UNITED STATES
NUCLEAR REGULATORY COMMISSION
WASHINGTON, D. C. 20555

January 31, 1990

SUBJECT: R. LICCIARDO - DIFFERING PROFESSIONAL OPINION (DPO) CONCERNING
(A) ZION 1/2 CONTAINMENT ISOLATION VALVES, AND
(B) METHODOLOGY USED FOR CALCULATING OFFSITE DOSES

CHRONOLOGY

Figure 14 F.2-19a Peak Clad Temperature - DECLG (C_D=1.0)
(Unit 1)

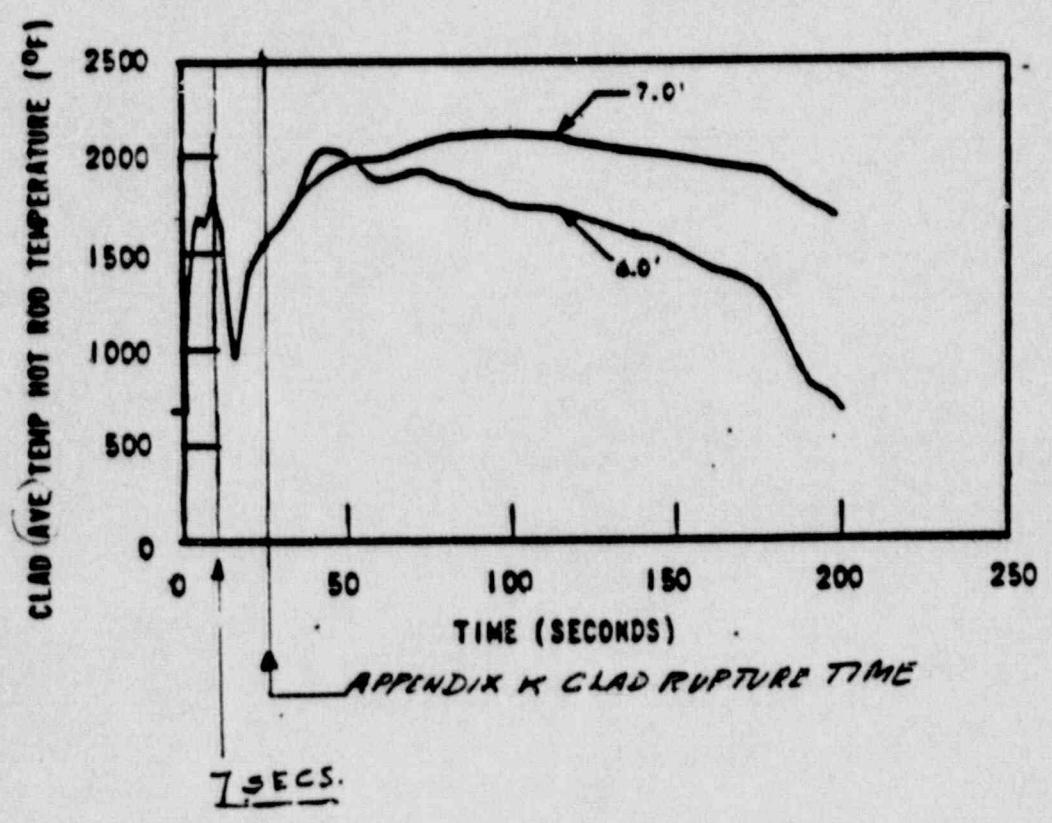
Exhibit 6 shows the average clad temperatures deriving from Appendix K calculations from the Zion FSAR, Figure 14 F. 2-19a, (Ref. 33). This shows that on infringement of DNBR at 1/10 second, average clad temperature increases very rapidly from a normal operating value of 720°F to at least 1350°F, and then to 1750°F, over a total period of seven seconds; thereafter temperature reduces rapidly to 1000°F at about 15 secs. from which it sharply increases ultimately to approx 2200°F.

FIGURE 1. Nominal CSAU Case

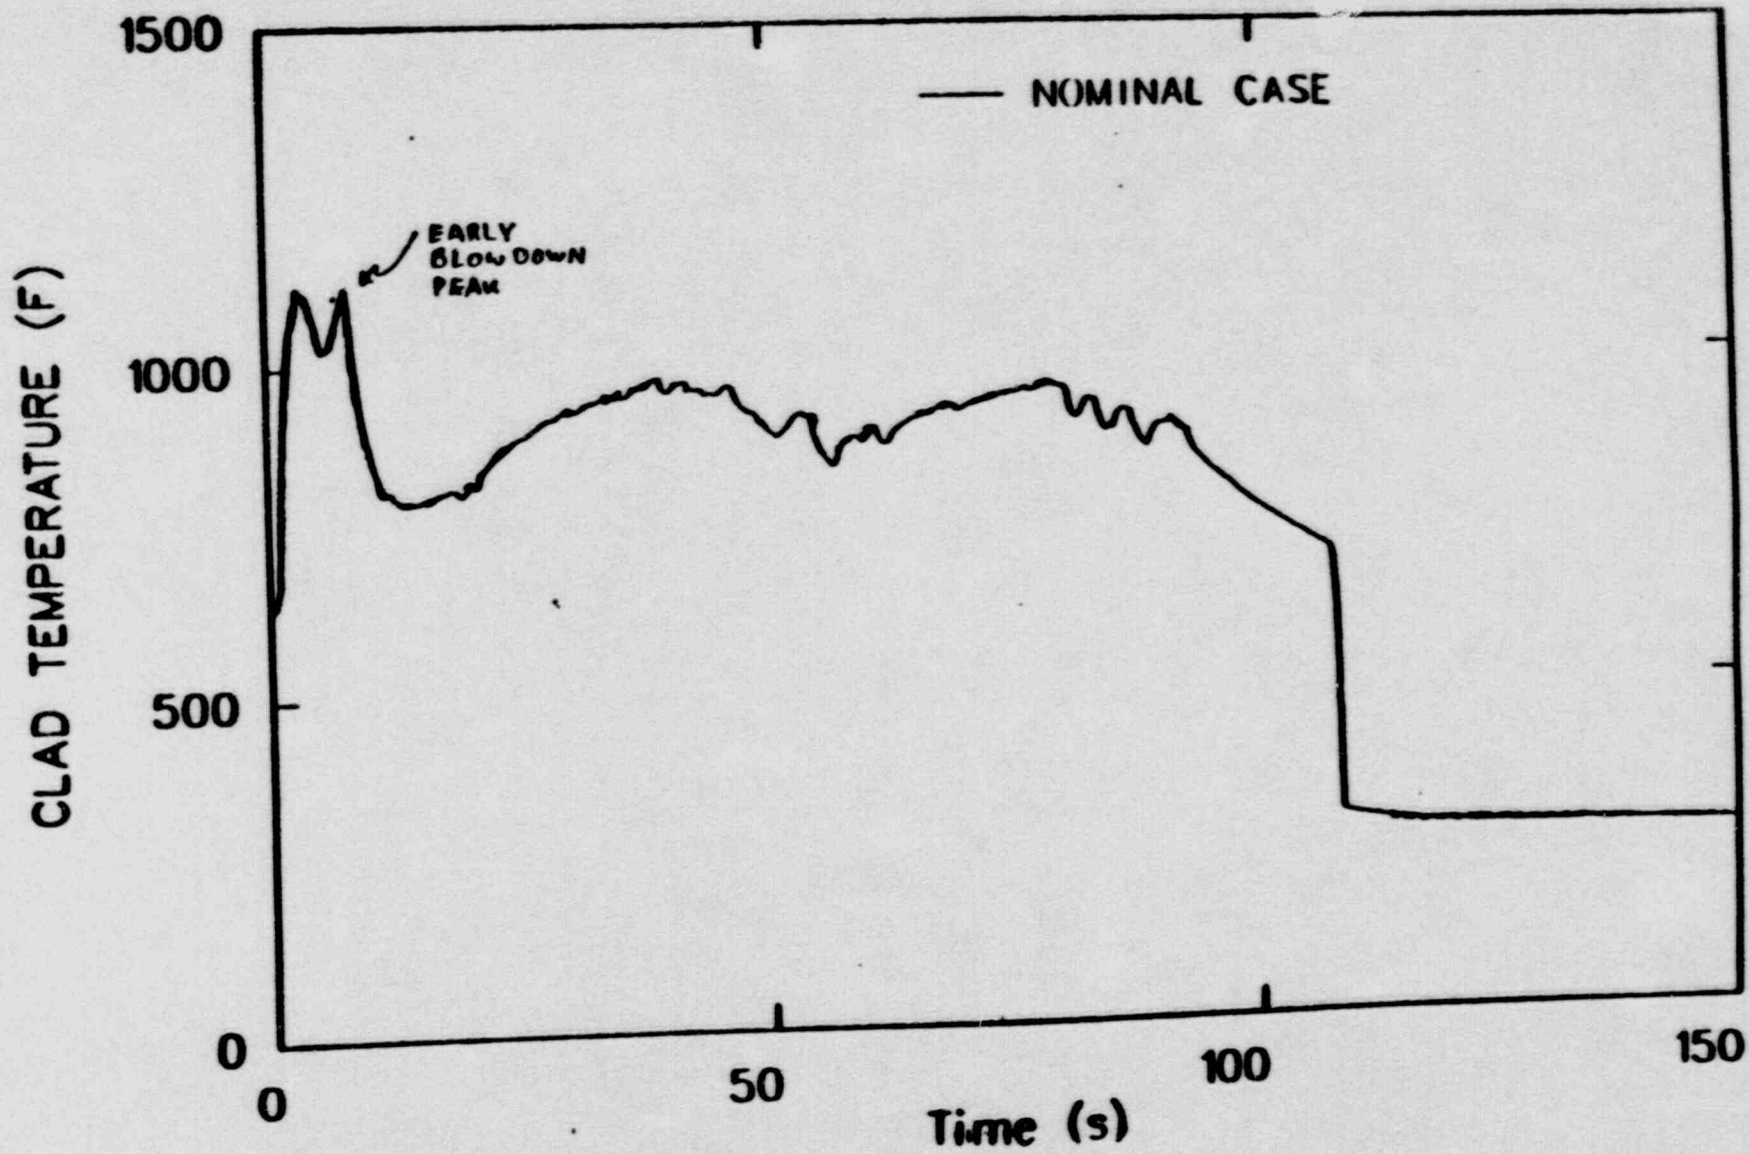
Issue 3 (p. 3-2) - "Exhibit 10 also shows that W fuels require a design limit of 1% on cladding strain as a design limit, and 1.7% as a damage limit. The work of this Section 3 will show how both of these limits can be exceeded inside the seven seconds on infringement of DNBR during the course of a LOCA,

As exhibit 10 states, these design values are for nominal operation or overpower conditions, not LOCA. Also, DNBR infringement has never been

considered the operant criterion for fuel failure during a LOCA. Although, I am told that this is not as clear as it should be in the standard review plan or any applicable reg. guides. Incidentally, PBF LOCA test do not show DNB occurring until 3-4 seconds for a very severe LBLOCA (reference 3).

Figure 2. Comparison of measured and calculated fuel rod plenum pressure versus time for Rod 3 of PBF test LOC-3.

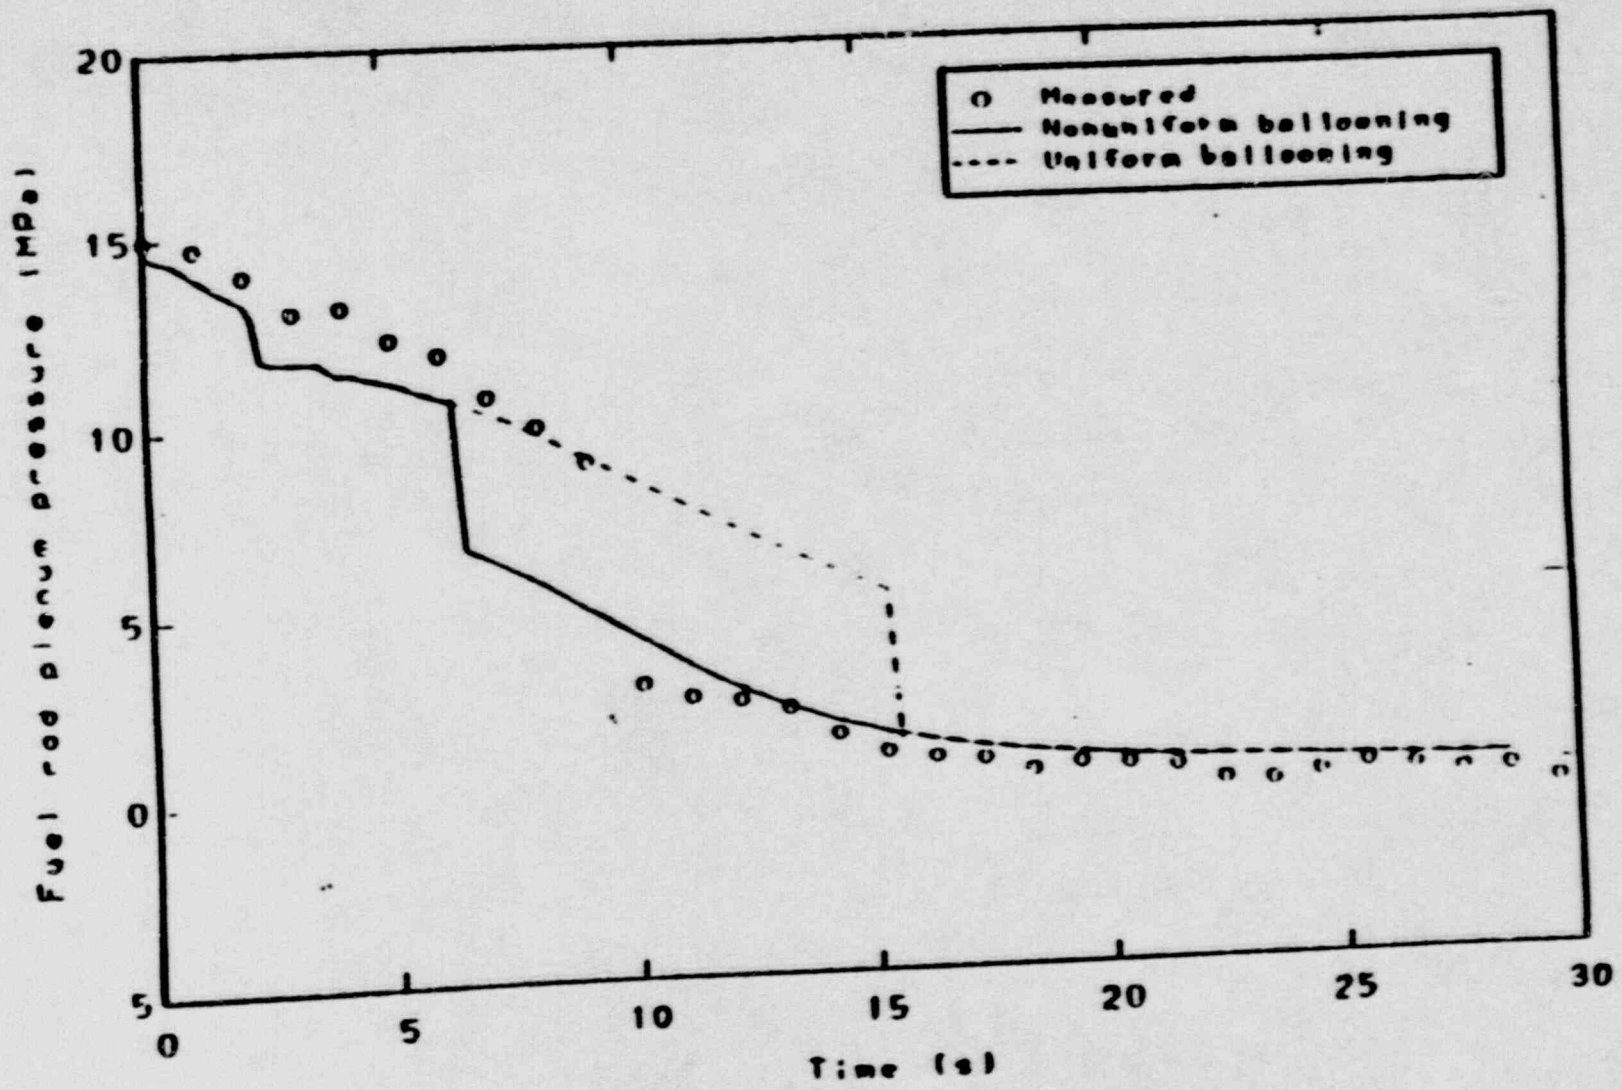
The basis for concluding that pin pressure increases during an LBLOCA blowdown is not known and contrary to the evidence. A series of 3 large break LOCA simulations (reference 3) (LOC-3, LOC-5, and LOC-6) were performed in PBF with well instrumented Zircaloy clad UO₂ fuel elements pre-pressurized to simulate low and high burnup PWR fuel. PBF blowdowns are quite severe compared to postulated PWR LBLOCA blowdowns. In PBF, the pressure decrease and rate of mass loss is very rapid. No good reverse flow blowdown heat transfer is evident as is the case in LOFT results or PWR analysis. Figure 2 (reference 6) shows the fuel rod pressure for rod 3 in test LOC-3. Also, shown are FRAP-T6 calculations using two different plastic deformation models. Clearly, pressure decreases throughout the transient. Figure 3 is a plot showing measured pressure decrease for Rod 11 in Test LOC-6. A FRAP-T6 characterization calculation was done for a postulated LBLOCA in Zion (reference 7) which also showed a pressure decrease throughout the transient.

Figure 3. Thermal and mechanical response of Rod 11 during Test LOC-6.

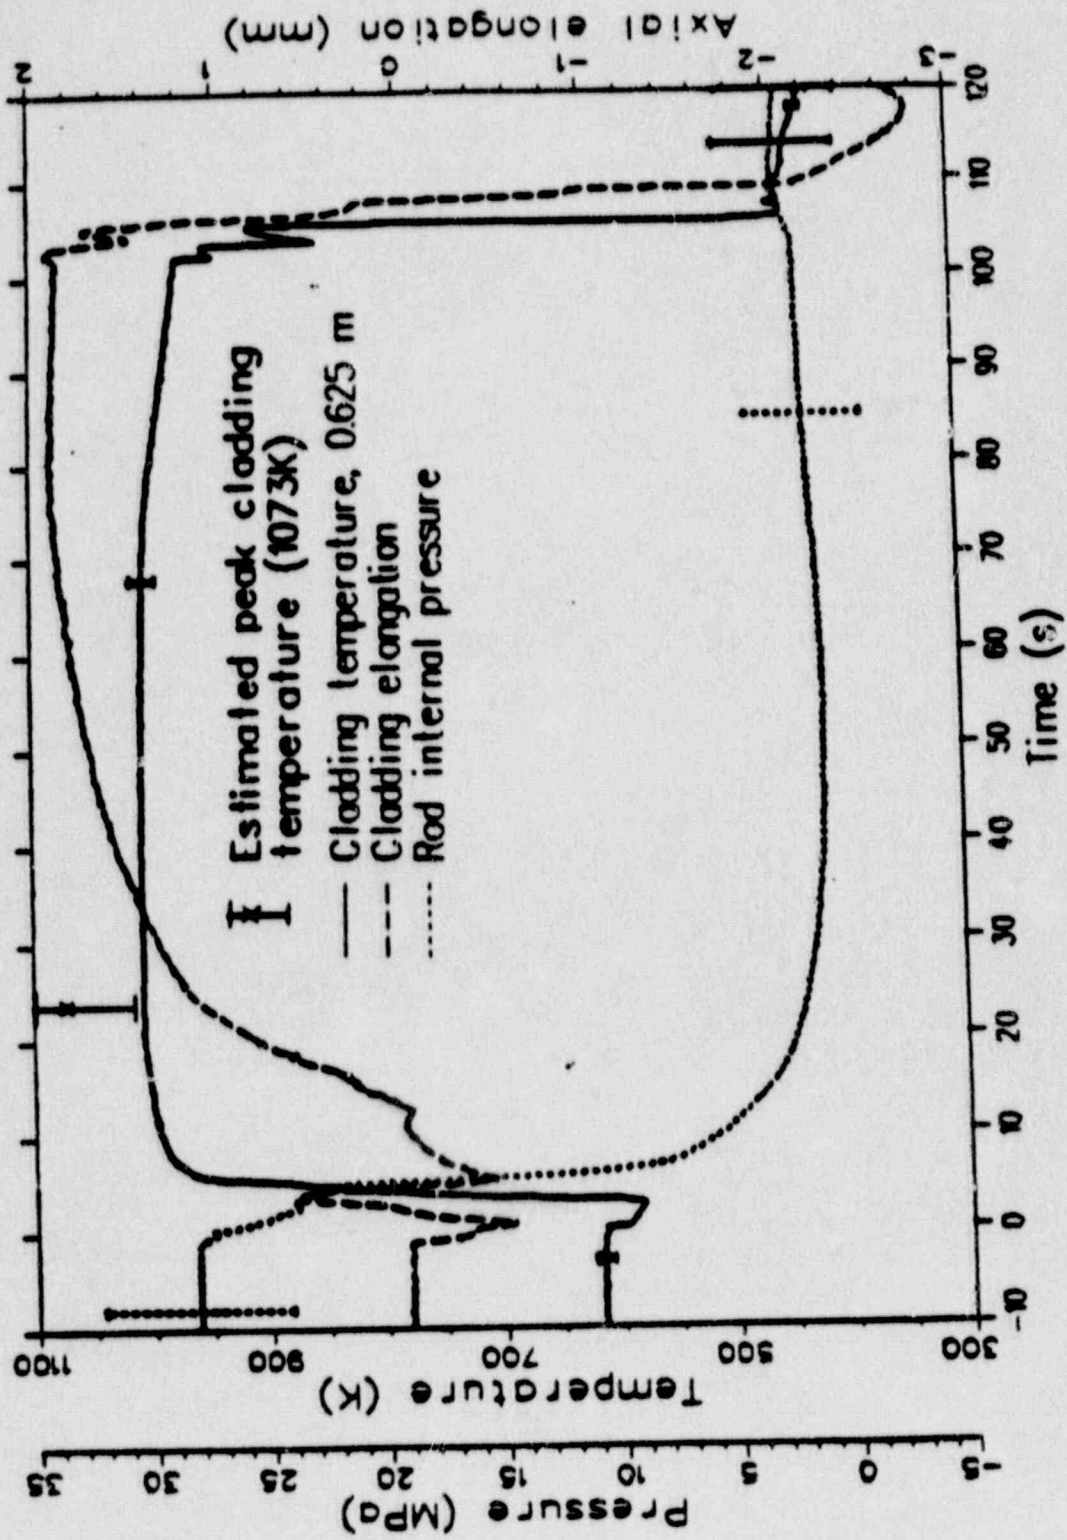
Issue 7 (p. 3-5) - Concern is expressed about the relevance of electrically heated rods used in defining the swelling and rupture curves in NUREG-0630. It is suggested that the TREAT data shown in NUREG-0630 (reference 6) would be more realistic. Also, on pp. 4-3 and 4-4, this concern is restated.

It is clear that TREAT data is anomalous compared to the electrically heated rods and is attributed to difficulties in obtaining accurate temperature data in the burst region. A better source of in-reactor data is the PBF series discussed previously. Figure 4 is a plot from NUREG 0630 (reference 8, exhibit 16). Included are data points with temperature uncertainty for the 9 ruptured rods in the PBF LOC series of tests, and the FRF data from TREAT. It is clear that the more recent PBF data is very consistent with the NUREG-0630 curves.
